MANDATORY SERVICE BULLETIN

Service Bulletin No. 253A
(Cancels Service Bulletin No. 219 and
Supersedes Service Bulletin No. 253)
Approved by FAA

SUBJECT: Replacement of Propeller Flange Bushings

MODELS AFFECTED: Part I: Lycoming Model O-340-A Series Aircraft Engines Equipped with Hartzell Controllable Pitch Propellers
Part II: Lycoming Model O-320 Series Aircraft Engines Equipped with Hartzell Controllable Pitch Propellers

Figure 1. Location of O-340 Crankshaft Flange Bushings

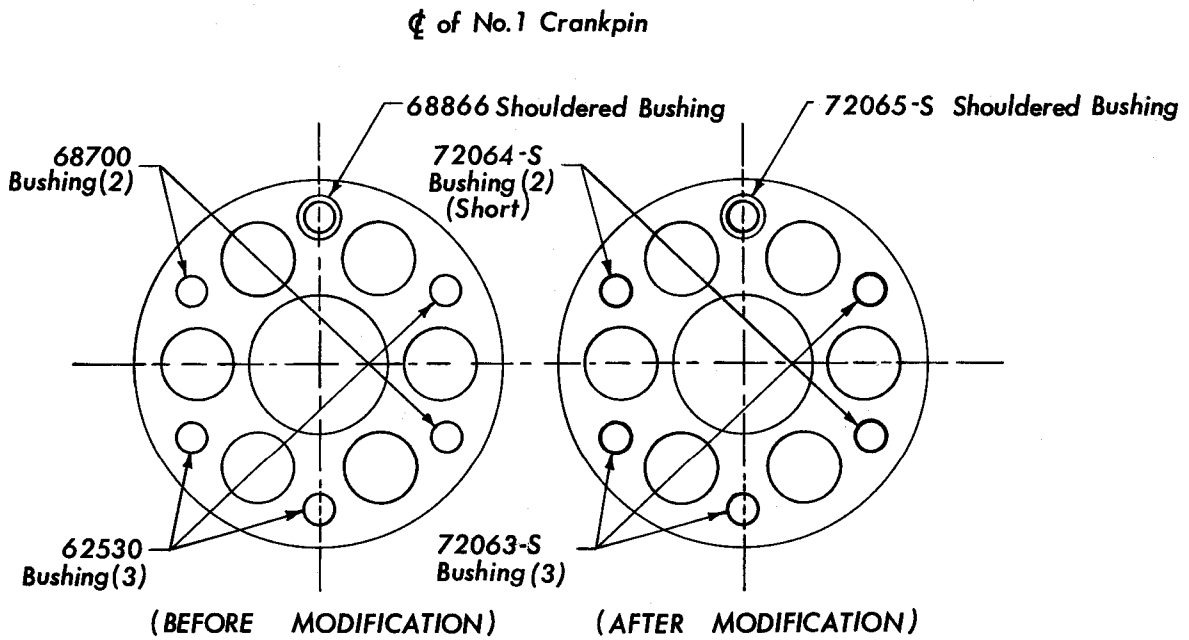
- a. Remove the propeller.
- b. Remove the ring gear assembly by tapping lightly with a hammer.
- c. Use the crankshaft flange bushing tool (Lyc. P/N 64869) to remove the shouldered bushing (Lyc. P/N 68866).

Reverse the puller and insert the new bushing (Lyc. P/N 72065-S). See Figure 1.

- d. Use the puller to remove the two (Lyc. P/N 68700) bushings. See Figure 1. Reverse the puller and install the two (Lyc. P/N 72064-S) bushings.
- e. Remove the remaining three (Lyc. P/N 62530) bushings. Figure 1. Install the new bushings (Lyc. P/N 72063-S).

Figure 2. Location of O-320 Crankshaft Flange Bushings

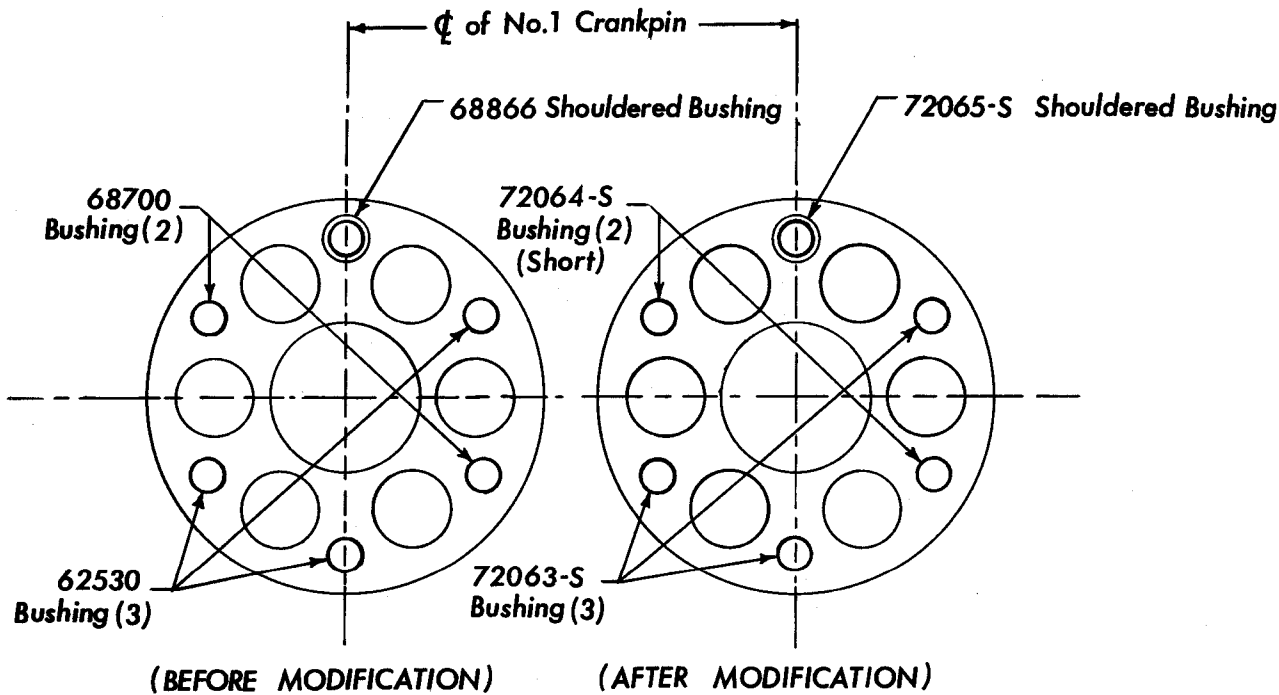
- a. Remove the propeller.
- b. Remove the ring gear assembly by tapping lightly with a hammer.
- c. Use the crankshaft flange bushing tool (Lyc. P/N 64869) to remove the shouldered bushing (Lyc. P/N 68866). Reverse the puller and insert the new bushing (Lyc. P/N 72065-S). Figure 2.
- d. Use the puller to remove the two (Lyc. P/N 68700)

bushings Figure 2. Reverse the puller and install the two (Lyc. P/N 72064-S) bushings.

- e. Remove the remaining three (Lyc. P/N 62530) bushings. Figure 2. Install the new bushings (Lyc. P/N 72063-S).

After the above modification has been accomplished, remove engine specification plate and stamp a "3" over the "1" on the model number than remount. For example, O-320-A1A after re-stamping, will become O-320-A3A and O-320-B1A will become O-320-B3A.
